SERVICE BULLETIN

ENGINE – HP TURBINE ROTOR AND STATOR ASSEMBLY – PROVIDE NEW STAGE 2 DUCT SEGMENTS
INCORPORATING REVISED COATING REQUIREMENTS – CATEGORY CODE 7 – MOD.ENG-72-0085

V2500-ENG-72-0085

Location of stage 2 HPT duct segments
Fig.1

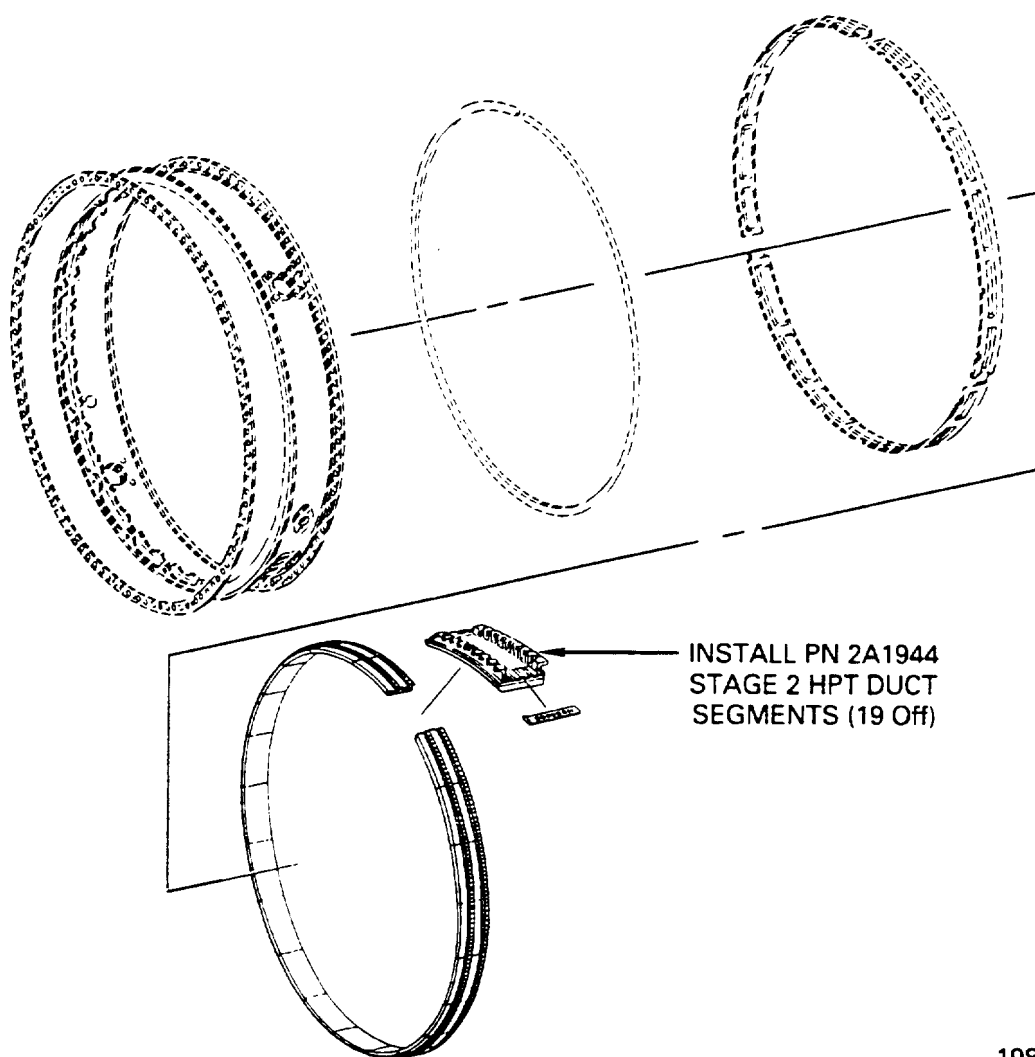
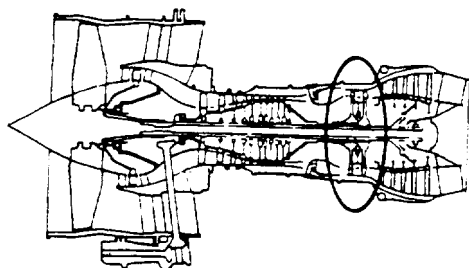
- (a) A new Stage 2 HPT Duct Segment has been provided featuring improved coating to enhance performance.

(1) Replace the 2A0108 Stage 2 HPT Duct Segments with 2A1944 Stage 2 HPT Duct Segments (19 off) by the approved procedure in Reference (2), Chapter/Section 72-45-20, Assembly-02.

NOTE: The new Stage 2 HPT Duct Segments must be replaced in complete sets only. Do not mix the new segments with the old segments.
